Access Compliance Report

Public Rights-of-Way

(Curb Ramps)

Intersection ID: 16469	Main Street: COLVILLE_RD	Cross Street: SCOTLAND_AV	Location: NW
ADA ID: F2D71D8BAEA0	Ramp Type: PerpDiag	Initial Pass/Fail: Fail	Overall Compliance: No
		Severity Score: 12.5

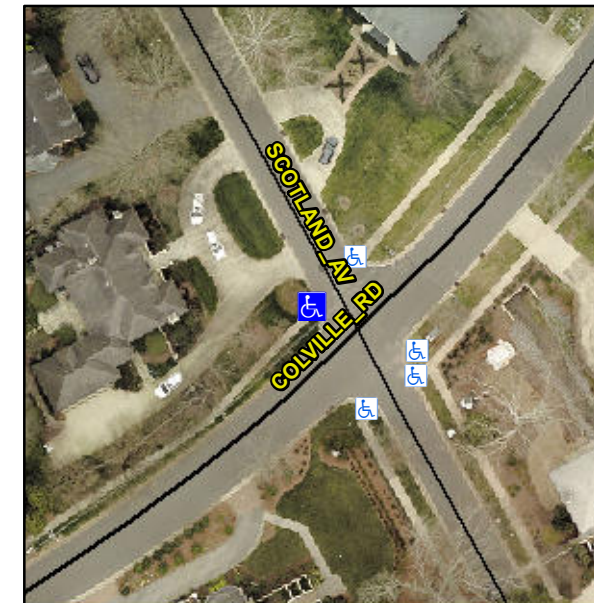
Not Found, R304.2.2

Compliance	Description	Data	Compliance	Description	Data
N/A	Ramp Length (in)	80.0	No	Ramp Slope (%)	9.3
Yes	Ramp Width (in)	48.0	Yes	Ramp XSlope (%)	0.5
N/A	Flare Type LT	N/A	N/A	Flare Type RT	N/A
N/A	Flare Slope LT (%)	N/A	N/A	Flare Slope RT (%)	N/A
N/A	Flare Traversable LT?	N/A	N/A	Flare Traversable RT?	N/A
N/A	Landing Length (in)	N/A	N/A	DWS Provided?	N/A
N/A	Landing Width (in)	N/A	N/A	DWS Contrast?	N/A
N/A	Landing Slope (%)	N/A	N/A	DWS Length (in)	N/A
N/A	Landing X Slope (%)	N/A	N/A	DWS Full Width?	N/A
N/A	Landing Curb? (Y/N)	N/A	N/A	DWS Offset (in)	N/A
N/A	Shared Landing?	N/A			
N/A	Gutter Ponding?	N/A	N/A	Gutter Slope (%)	N/A
N/A	Gutter Lip Ht (in)	N/A	N/A	Gutter X Slope (%)	N/A
N/A	Painted X Walk1?	No	N/A	Painted X Walk2?	No
	X Walk 1 Direction	To S		X Walk 2 Direction	To NE
N/A	X Walk 1 Width (in)	N/A	N/A	X Walk 2 Width (in)	N/A
	X Walk 1 Slope (%)	1.0		X Walk 2 Slope (%)	0.4
	X Walk 1 X Slope (%)	0.1		X Walk 2 X Slope (%)	1.4

Remove & Replace Curb Ramp With Two New Directional Ramps or Equivalent.
